STAFF RECOMMENDATION

1212 McChesney Avenue

July 19, 2017

Application: New construction—infill and outbuilding

Figure 2. The HPR filed for the new development

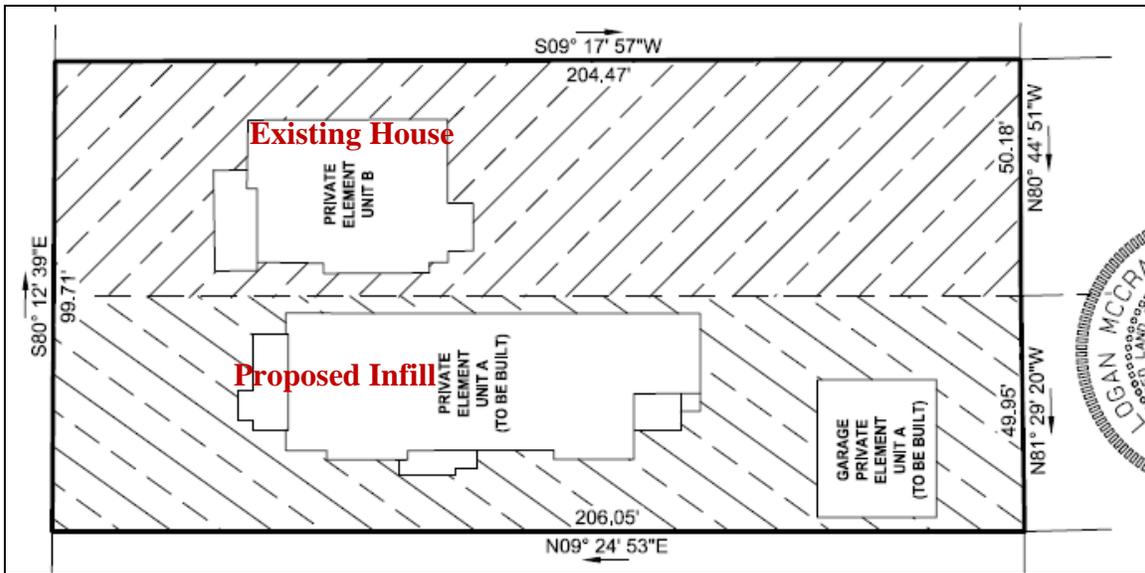
The owner of the property has filed a Horizontal Property Regime (HPR) to construct a second, detached single-family residence on the right half of the property (Figure 2).

The HPR will allow the owner of the property to sell off the property separately from the existing house at 1212 McChesney. The Metro Historic Zoning Commission does not have the authority to determine the number of dwelling units allowed on a property. However, it can determine the appropriateness of the height, scale, location, and form of the second dwelling unit.

The two houses on the lot will be separated by eight feet (8’). Staff’s analyzed the distance between houses on this street that are on fifty-foot (50’) wide lots like this one. Staff found these houses are between eight and nineteen feet (8’-19’) apart, with the approximate average being a distance of fifteen feet (15’). There are two houses across the street that are approximately eight feet (8’) apart, as is proposed for this site. The new infill is shifted close to the existing house in order to allow for a driveway on the right side of the property line. Staff recommends that the infill be shifted a minimum of two feet (2’) to the right so that there is a minimum of ten feet (10’) in between the two

houses. This will situate that house five feet (5') from the HPR line. If the HPR line were a side property line, then base zoning would require a five foot (5') side setback.

With the condition that the infill be situated a minimum of ten feet (10') from the existing house, staff finds that the project's setback and rhythm of spacing meet Section III.C. of the Inglewood Place Neighborhood Conservation Zoning Overlay design guidelines.

① Proposed Site Plan
 Scale 1/16" = 1'-0"

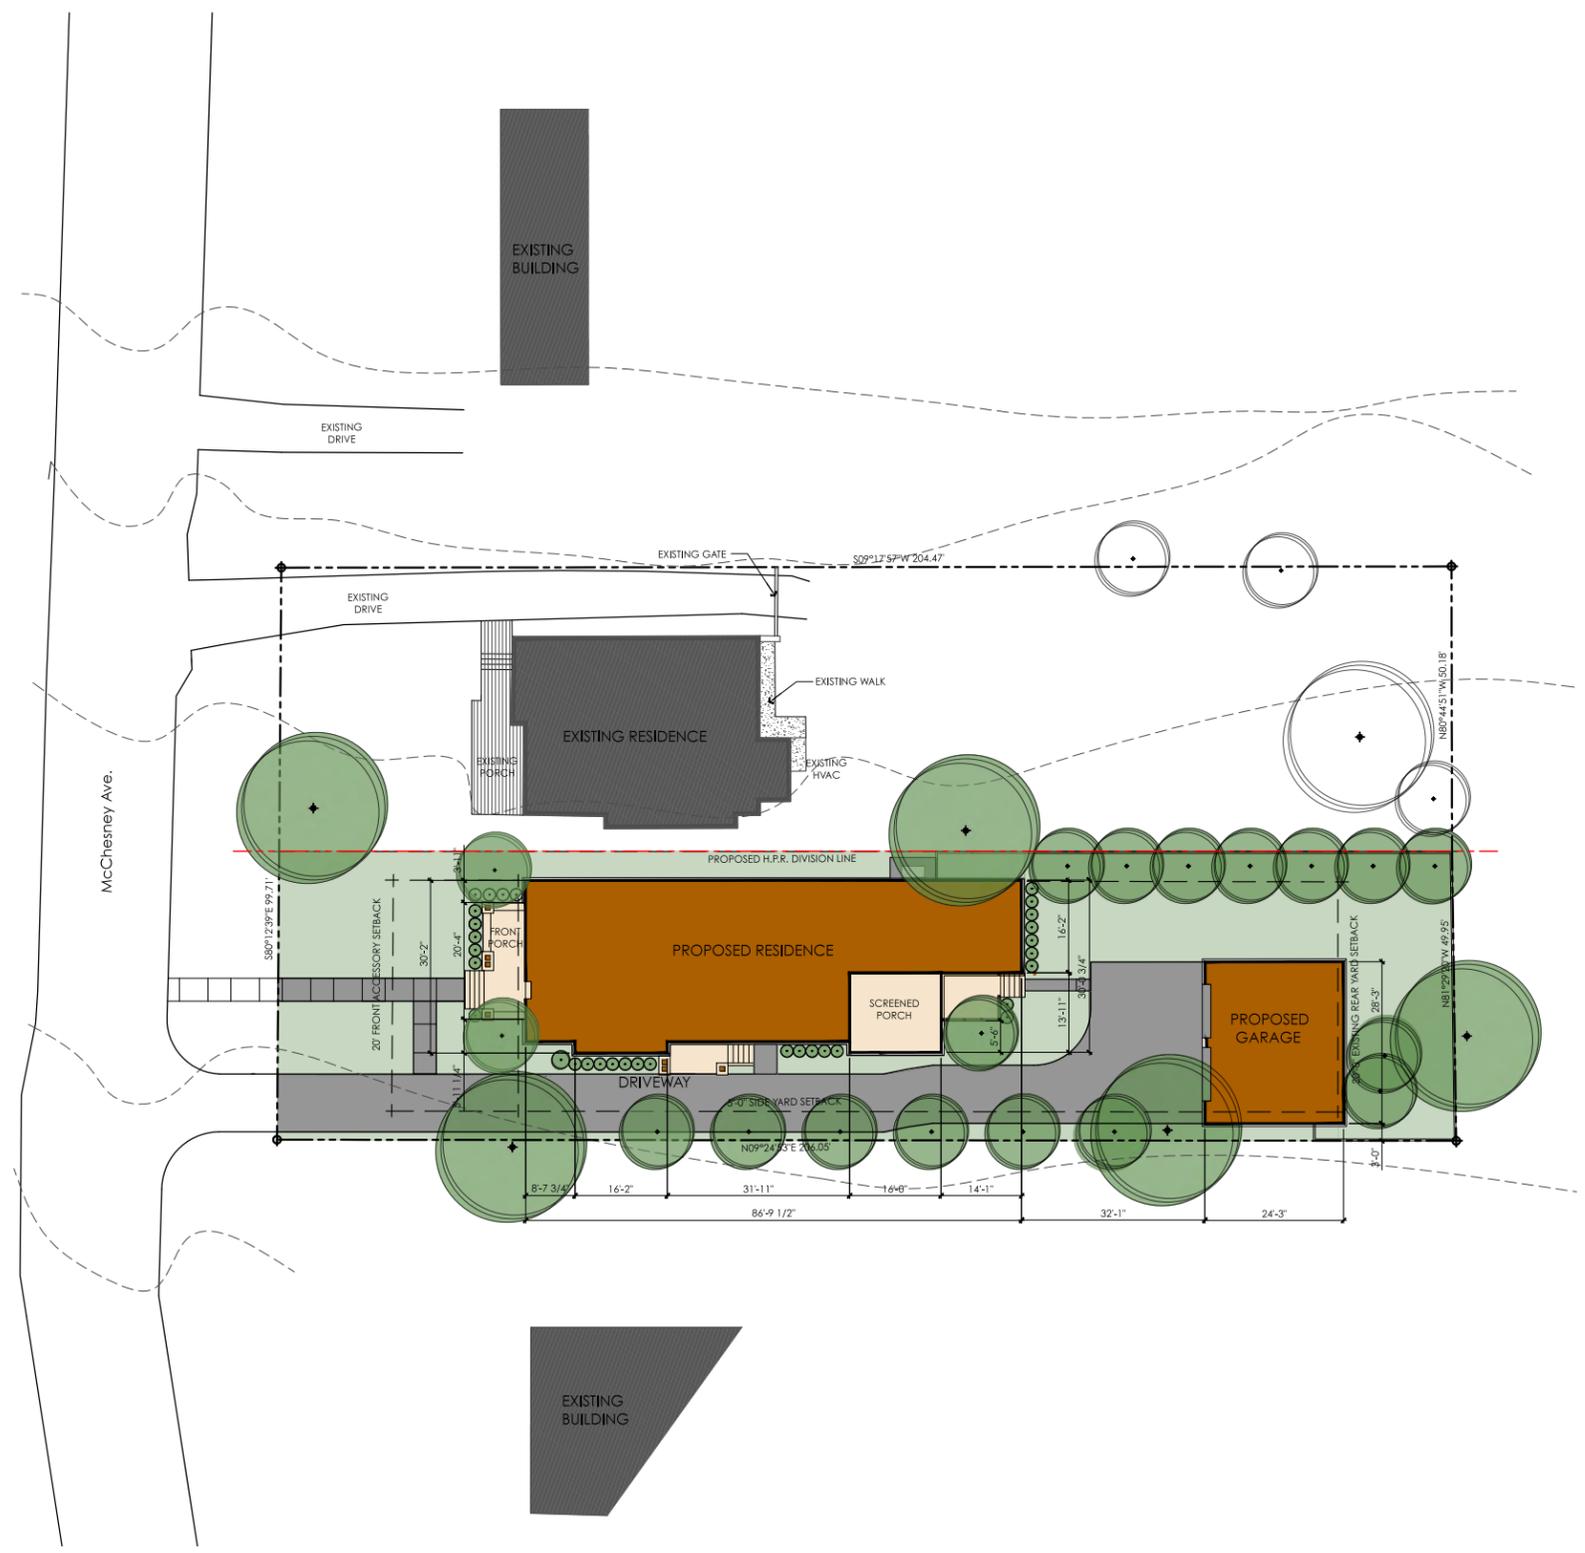
The infill's front setback will match that of the existing house on the lot. The front wall of the infill will line up with the front wall of the existing house. The new infill will be approximately twelve feet (12') from the right side property line, and will be approximately seventy-six feet (76') from the rear property line. These meet the base zoning setbacks.

Appurtenances & Utilities: A new curb cut and driveway will be created on the right side, which is appropriate since there is no alley access and driveways are common on this street and in the Inglewood Place neighborhood. The location of the HVAC and other utilities was not noted. Staff recommends that the HVAC be located on the rear façade, or on a side façade beyond the midpoint of the house.

1 Proposed Front Elevation

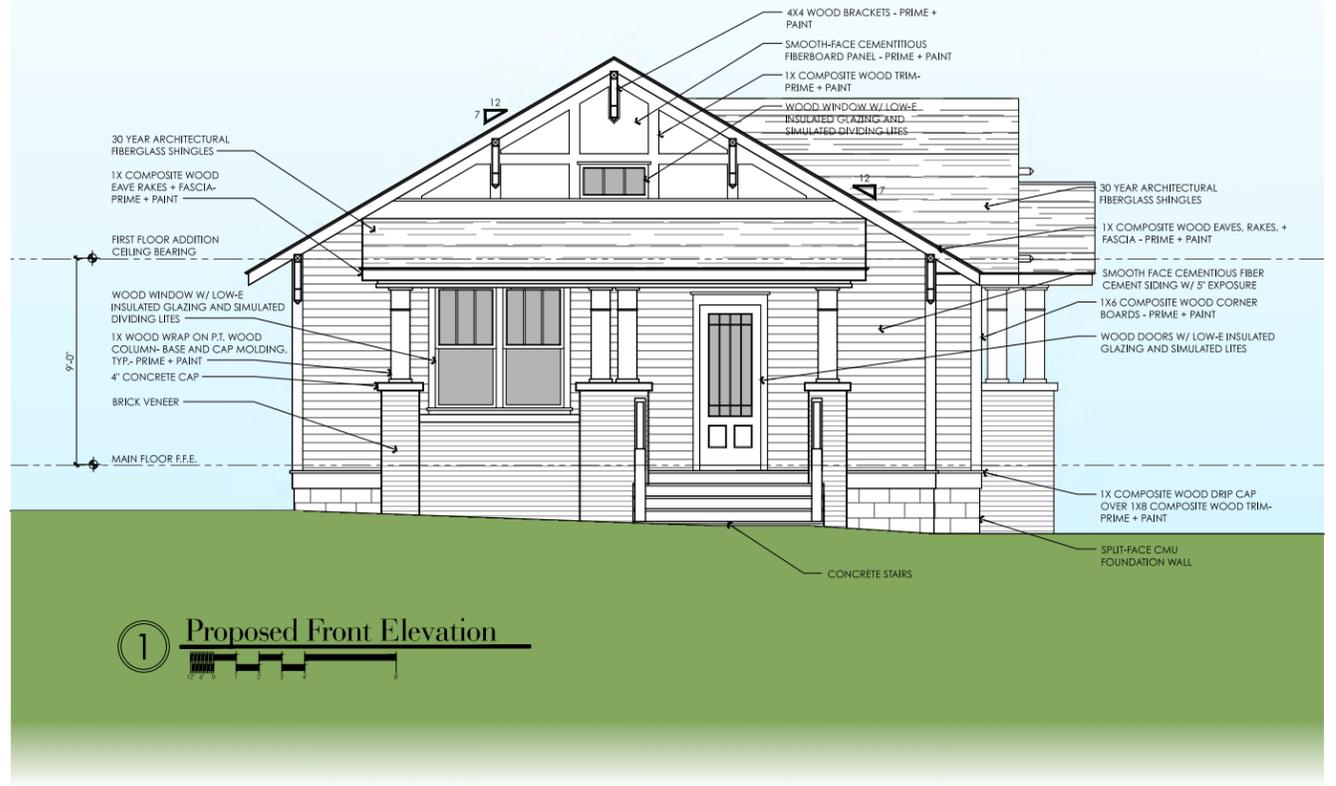
Height & Scale: The proposed infill is one story, with an eave height ranging from nine foot (9'6") to eleven feet (11') above grade and a ridge height of twenty feet, six inches (20'6") above grade. Staff finds that the height and scale meet the immediate context where houses are largely one and one-half stories with heights ranging from fifteen to twenty-five feet (15'-25'). The existing house on the lot has an eave height of approximately ten feet (10') and ridge height of approximately twenty-three feet (23'). The proposed infill is therefore in keeping with the height of the neighboring house on the lot. The foundation height will range from one to two feet (1'-2'), due to the slope. Staff recommends approval of the finished floor height to ensure it is compatible with the finished floor height of the existing house on the lot.

The house will be twenty-eight feet (28') wide at the front. It will expand to a thirty foot (30') width. A covered side entrance on the right side will bring the maximum width of the house to thirty-three feet, six inches (33'6"). By comparison, the existing house on the lot is thirty-feet (30') wide at the front, with a maximum width of thirty-two feet (32'). Staff finds that the proposed width meets the historic context. The infill will have a depth of eighty-seven feet (87'), not including an eight foot (8') deep front porch. The total footprint of the house will be approximately two thousand, five hundred and fifty square feet (2,550 sq. ft.).

Roof form: The primary roof form is a front-facing gable with a 7/12 pitch. The right façade contains a cross gable, a side entry porch, and a rear screened porch, all with a

6/12 gable form. Staff finds that the proposed roof forms are compatible with the historic Inglewood Place neighborhood and meet Section III.E. of the Inglewood Place Neighborhood Conservation Zoning Overlay design guidelines.

Orientation: The infill is oriented to face McChesney, which is appropriate. The primary entrance is behind a partial-width, eight foot (8') deep front porch. The right façade contains a secondary side entrance, behind a covered, five foot (5') deep porch. Staff finds that the side entrance will read as a secondary entrance and will not affect the house's orientation towards McChesney. A front walkway will lead from the street to the front porch. The site lacks an alley, so vehicular access will be via a new curb cut and driveway to the right of the house. The driveway will extend to the rear yard. Staff finds that the project's orientation meets Section III.F. of the Inglewood Place Neighborhood Conservation Zoning Overlay design guidelines.

Proportion and Rhythm of Openings: The windows on the proposed infill are all twice as tall as they are wide, thereby meeting the historic proportions of openings. There are no large expanses of wall space without a window or door opening. Staff finds the project's proportion and rhythm of openings meet Section III.G. of the Inglewood Place Neighborhood Conservation Zoning Overlay design guidelines.

Staff recommends final approval be obtained for the roof color and texture, a brick sample, the porch railing material and design, and all final window and door selections. With staff's approval of all final material choices, staff finds that the project's materials meet Section III.D. of the Inglewood Place Neighborhood Conservation Zoning Overlay design guidelines.

DATE OF ISSUANCE:
06 July 2017
PROPOSED GARAGE ELEVATIONS

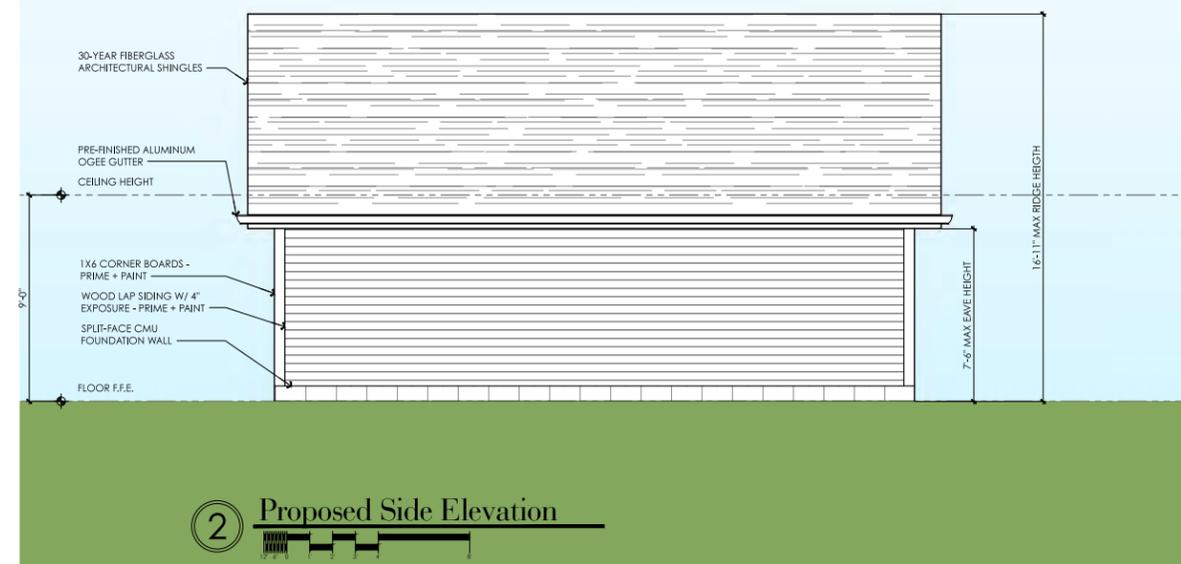
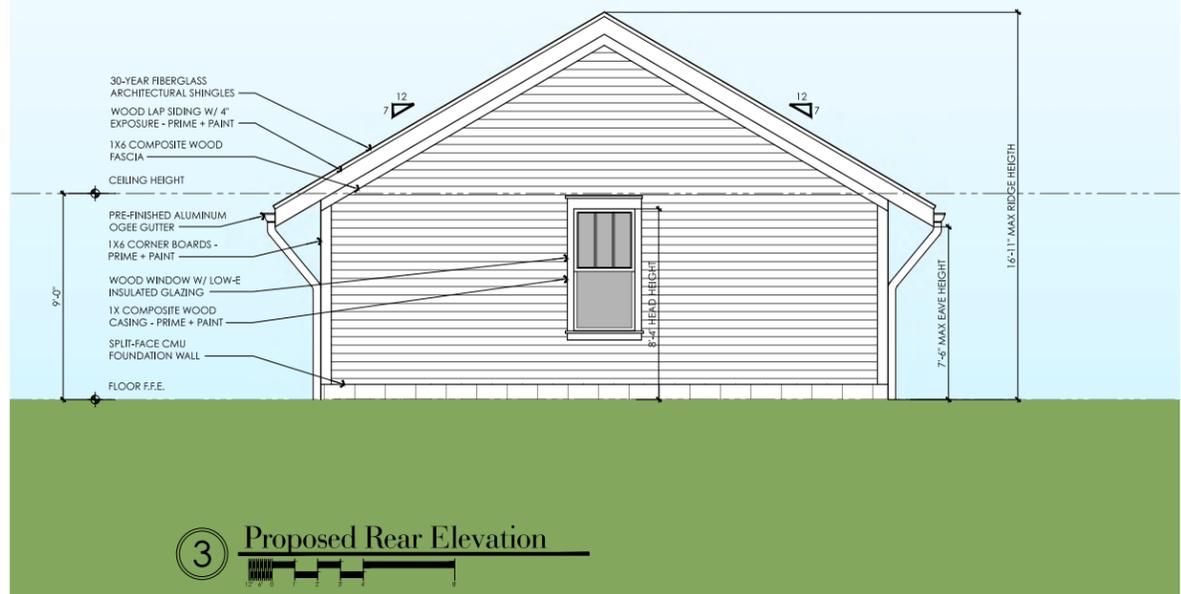
Proposed Element	Proposed Form	Typical of district?
Primary form	Side Gable	Yes
Primary roof slope	7/12	Yes

Since the roof form and slope are similar to historic outbuildings, staff finds that the outbuilding meets Section III.H.3 of the design guidelines.

Design Standards: The accessory structure has a simple, utilitarian design that is appropriate for outbuildings. Its roof form, detailing, and form do not contrast greatly with the primary structure. The outbuilding is in a minimally-visible at the rear of the lot. Staff finds that the outbuilding's design meets section III.H.2 of the design guidelines.

Potential maximums (heights to be measured from grade)	Existing conditions (height of historic portion of the home to be measured from finished floor)	Proposed
Ridge Height	25' or height of primary structure, whichever is less	20'6"	16'11"
Eave Height	10' or less than primary structure eave height	10'3"	7'6"

With the staff’s final approval of the windows and doors and roof shingle color, staff finds that the known materials meet Section III.H. of the design guidelines.
